Austin MG

SUBJECT: COOLING FAN THERMAL CUT-OUT INSTALLATION

MODELS: 1977 MGB

20 Amp Thermal Cut-Out Switch

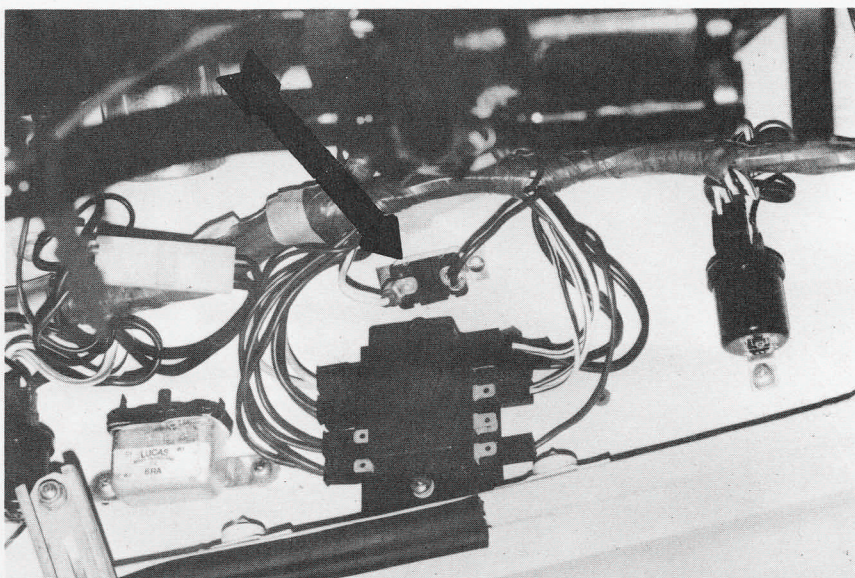
As a courtesy service to all owners of 1977 MGBs we would ask that during pre-delivery or at the next convenient service, the in-line fuse which controls the cooling fans be removed and replaced with a thermal cut-out which is available under part #BLM 601018.

This thermal cut-out has a maximum rating of 20 amps and is self-healing, in the unlikely event that an overload condition should occur.

The in-line fuse is located on the right inner valance of the car, underneath the fuse block, has a green lead on one side and a white with brown tracer on the other. The diagram below indicates the correct location of the thermal cut-out.
